FINAL SITE GRADING CONSTRUCTION PLANS  
FOR  
**LORSON RANCH EAST FILING NO. 3**  
FINAL GRADING / EROSION CONTROL PLANS

**COVER SHEET**  
**FINAL GRADING AND EROSION CONTROL PLAN**

<b>CORE ENGINEERING GROUP</b>	
1500 S. 151ST AVENUE, SUITE 100, COLORADO SPRINGS, CO 80903 PH: 719.570.1100 CONTACT: RICHARD L. SCHINDLER, P.E. EMAIL: Rich@ceg1.com	
PROJECT: LORSON RANCH EAST FILING NO. 3 PREPARED FOR: LORSON, LLC 212 N. WAHSATCH AVE, SUITE 301 COLORADO SPRINGS, COLORADO 80903 FONTAINE BLVD. - LAMPREY DR. COLORADO SPRINGS, COLORADO CONTACT: JEFF MARK	DATE: _____ DESCRIPTION: _____ NO. _____
DRAWN: RLS DESIGNED: RLS CHECKED: RLS	
<b>LORSON RANCH EAST FILING NO. 3          FINAL GRADING AND E.C. PLAN          EAST AREA</b>	
DATE: JANUARY 15, 2019 PROJECT NO: 100.049 SHEET NUMBER: C4.1 TOTAL SHEETS: 6

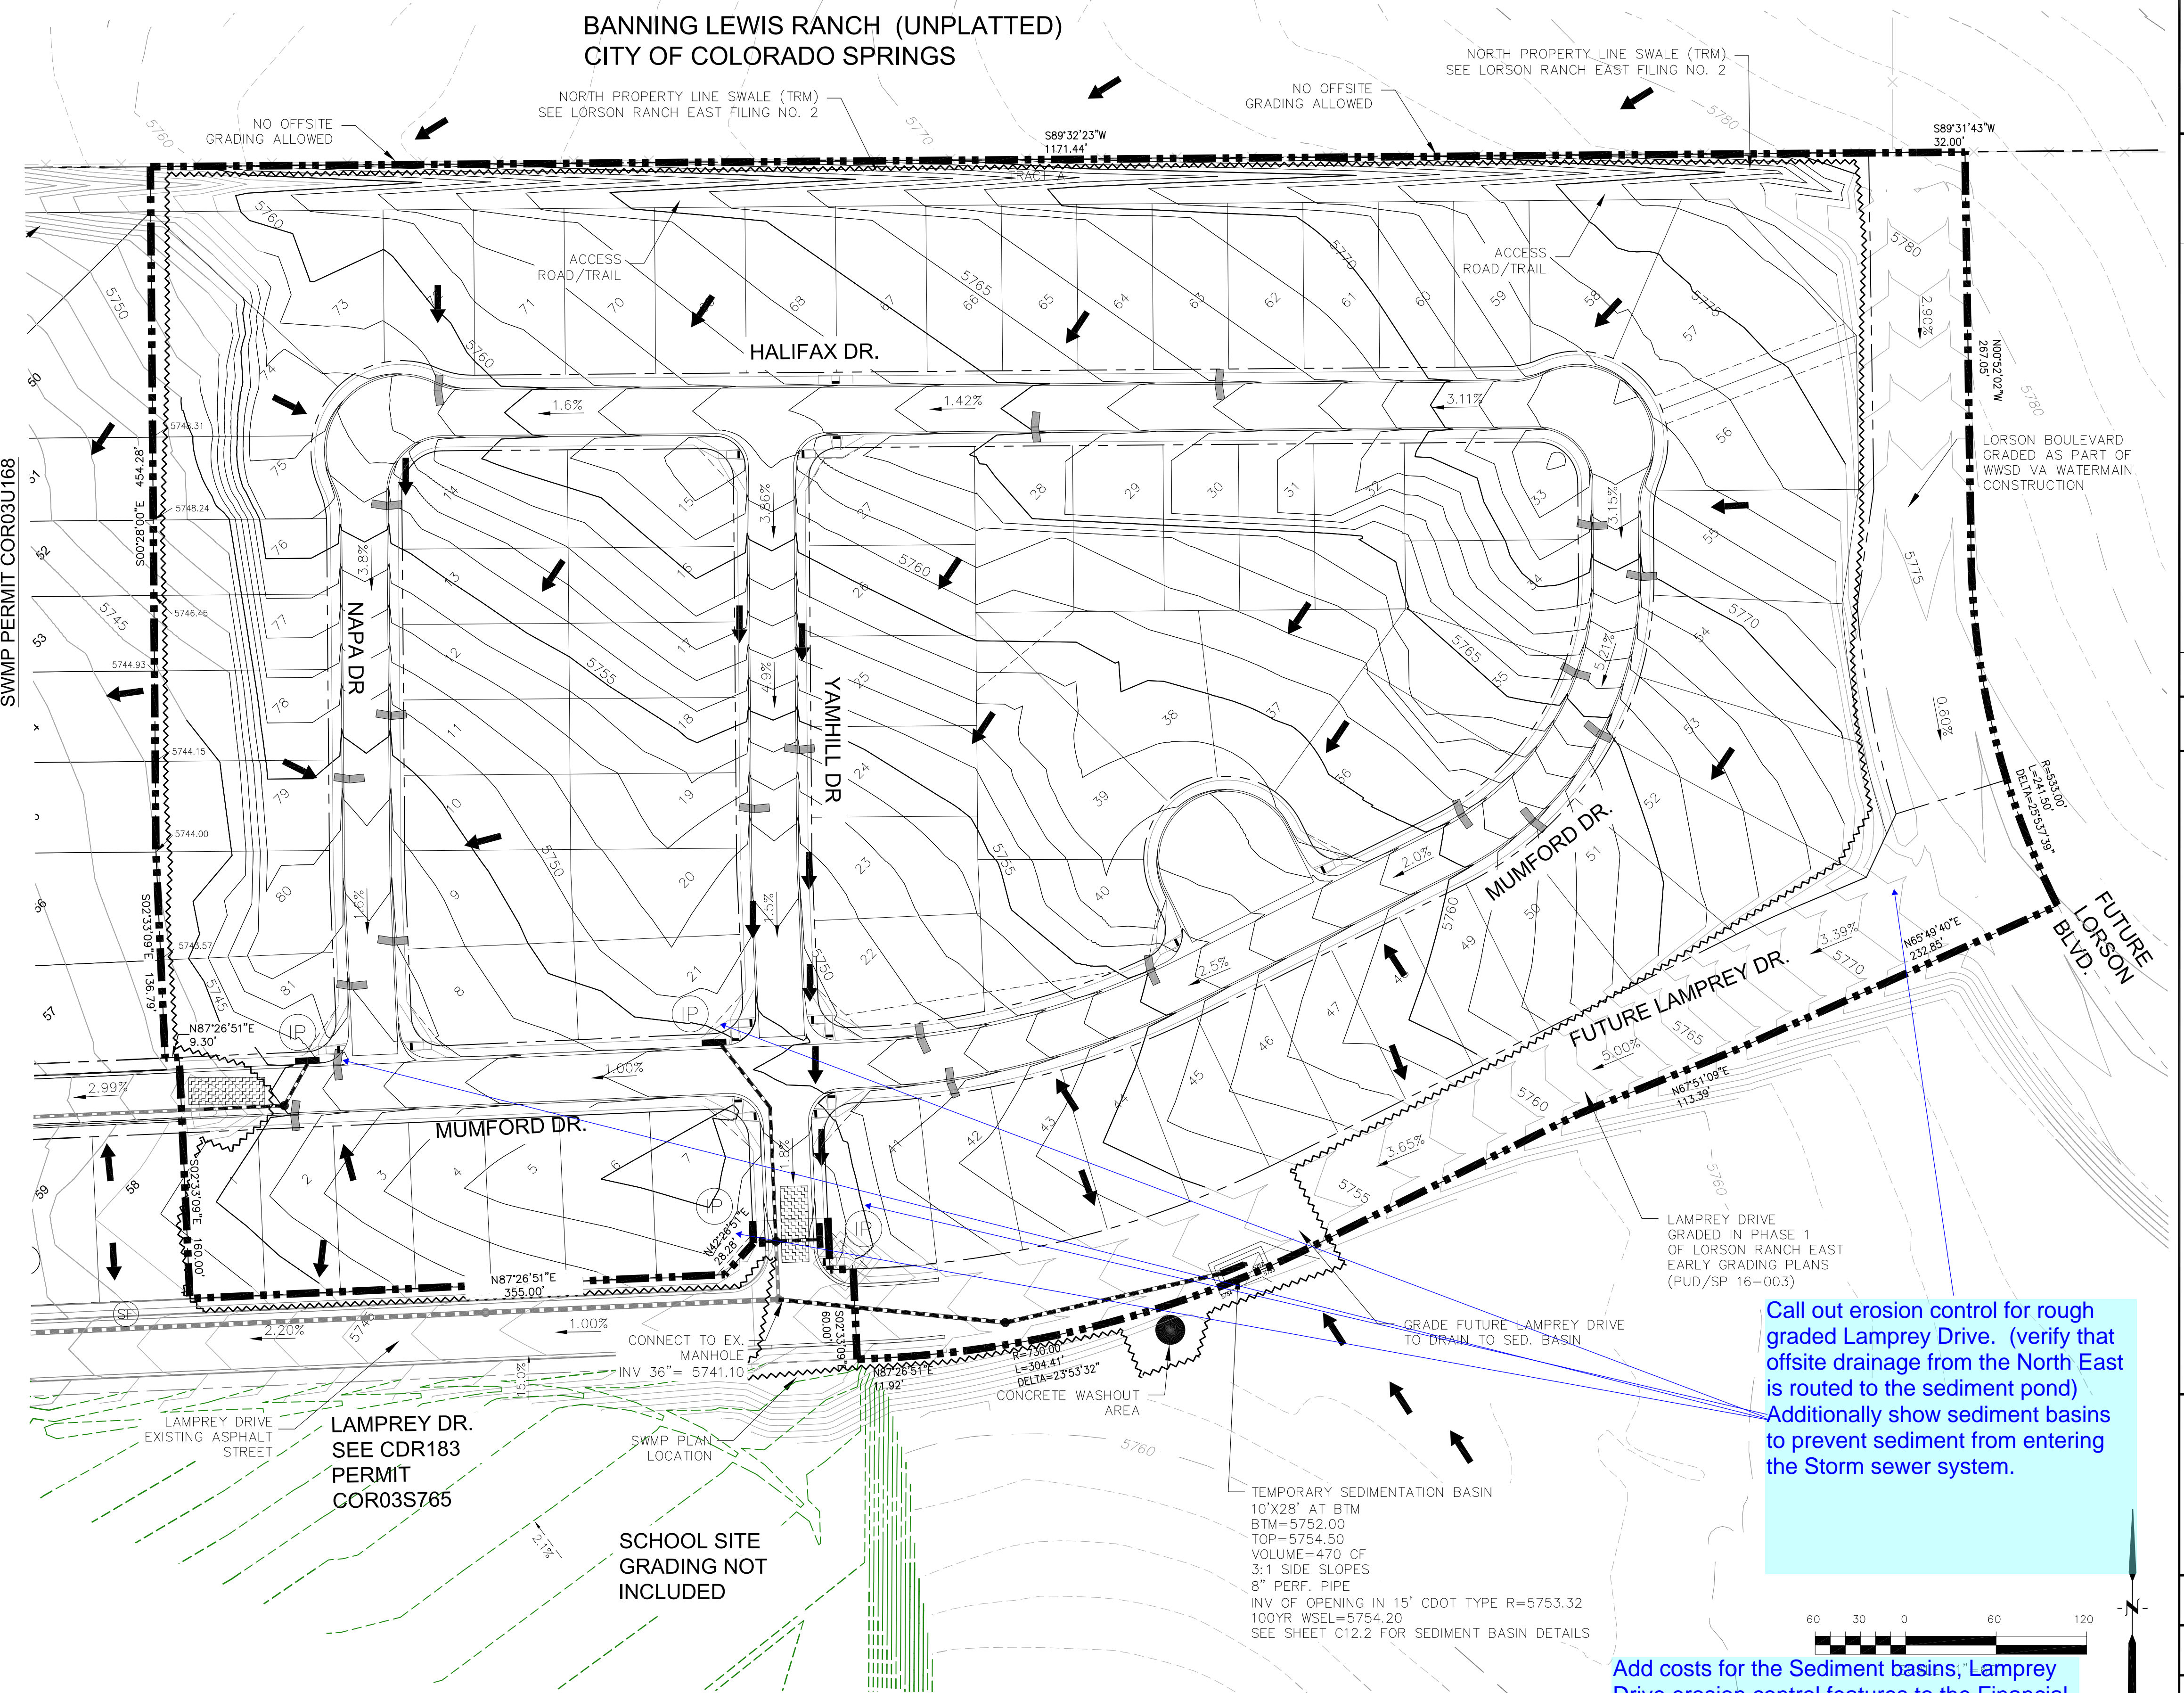
Call out erosion control for rough graded Lamprey Drive. (verify that offsite drainage from the North East is routed to the sediment pond)  
 Additionally show sediment basins to prevent sediment from entering the Storm sewer system.

Add costs for the Sediment basins; Lamprey Drive erosion control features to the Financial Assurance Estimate FAE
